Appliance Standards Awareness Project  
American Council for an Energy-Efficient Economy  
Natural Resources Defense Council

August 29, 2022

**RE: Docket Number EERE-2017-BT-STD-0007: Energy Conservation Standards for Commercial Refrigerators, Freezers, and Refrigerator-Freezers**

**Figure 1:** Daily energy usage (kWh/day) of SOC.RC.M (left) and VOP.SC.M (right) CREs as a function of TDA (ft<sup>2</sup>) for models in the CCD database<sup>14</sup> (blue circles). DOE’s current standard level (black line) and DOE’s max-tech level (gray diamond) are also shown.

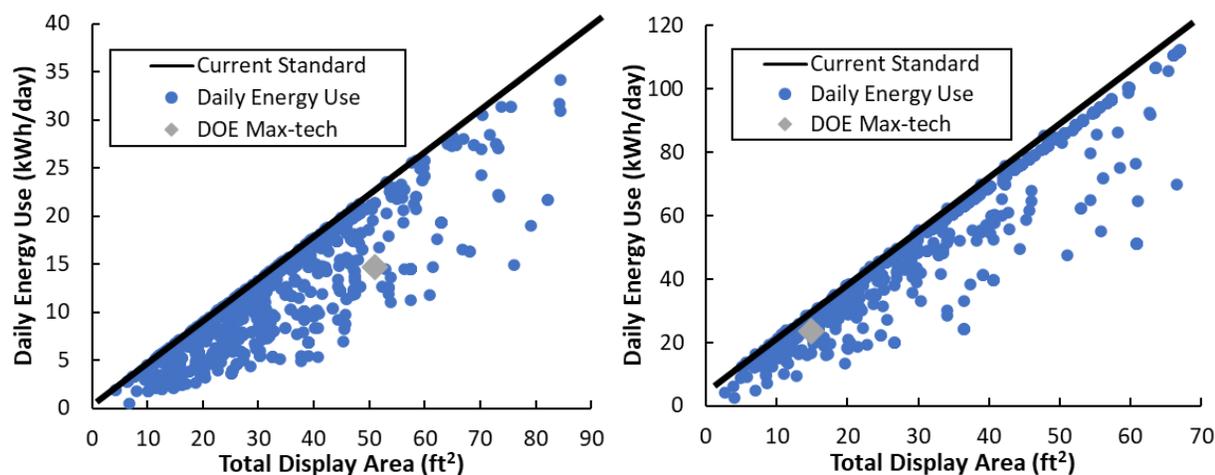
**We encourage DOE to evaluate max-tech levels for CREs that are at least as high as the most efficient models available on the market.** For several of the equipment classes analyzed, multiple models at comparable sizes in DOE's compliance certification database (CCD) exceed the max-tech efficiency level in the engineering analysis. For example, as shown in Figure 1 (left), DOE's max-tech level for the representative service over counter, remote condensing, medium-temperature (SOC.RC.M) unit is 14.7 kWh/day. However, there are multiple models in the CCD at a comparable size, ~45-55 ft<sup>2</sup> total display area (TDA), with energy consumption as low as about 10 kWh/day.<sup>11</sup> Figure 1 (right) similarly shows multiple models of vertical, open, self-contained, medium temperature (VOP.SC.M) units that significantly exceed DOE's max-tech level of 23.5 kWh/day at similar TDAs.<sup>12</sup> While a complete list of design options for these models was not readily available, high-efficiency evaporator fans, improved evaporator coils, and LED lighting are listed for certain SOC.RC.M units, while the referenced VOP.SC.M models use R-290 refrigerant. Similar results, wherein models are available beyond DOE's max-tech level, are found for additional equipment classes.<sup>13</sup>

Importantly, DOE's analysis shows that the Department's max-tech level is cost-effective for some of the evaluated classes, including both the SOC.RC.M and VOP.SC.M classes discussed. This suggests the potential for additional cost-effective energy savings opportunities at higher ELs. Thus, we encourage DOE to set max-tech levels that are at least as high as efficiencies currently available on the market.
